Item 5.**Development Application: 79-83 Abercrombie Street, Chippendale**

File No.: D/2018/947

Summary

Figure 18: The applicant's GFA diagrams with the additional floor space indicated by the red dotted lines

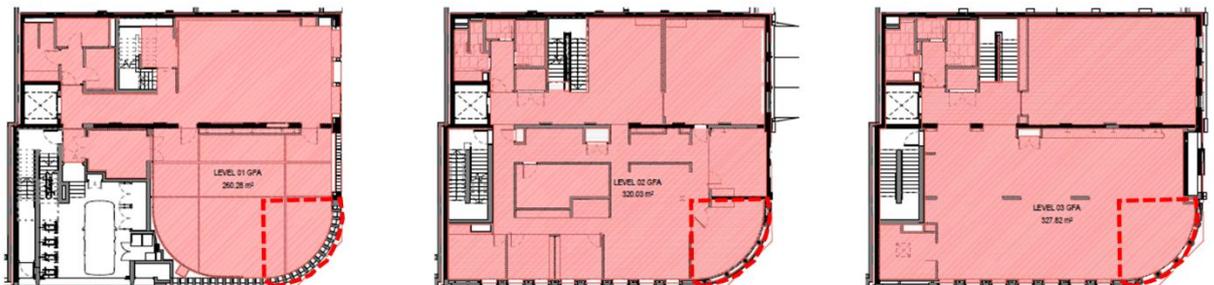
42. The site is subject to a floor space ratio of 1.75:1. The proposed development has a floor space ratio of 2.31:1.
43. The existing building has a gross floor area of 872.04sqm and a floor space ratio of 2.21:1 which presently exceeds the maximum floor space control. The proposal includes the provision of an additional 36.09sqm of floor space which results in a variation to the floor space ratio control of 31.5%.

44. The proposal includes the demolition of the building occupying the southern portion of the site (with the exception of the upper level Victorian facade), and replacement with a three storey building that will be located to the side of the retained building at 79 Abercrombie Street. The applicant attributes the non-compliant gross floor area to minor changes made to the building footprint, which include the infill of the existing landscaped area of the splayed corner of the site. The proposed addition incorporates well-articulated facades and a mix of materials to provide visual interest on the prominent street corner.

50. The development generally maintains the existing built form, with a minor change to the building footprint at the corner of Abercrombie and Myrtle Street. The density and scale of the built form would remain generally consistent with the established buildings on the site, and adjoining development.
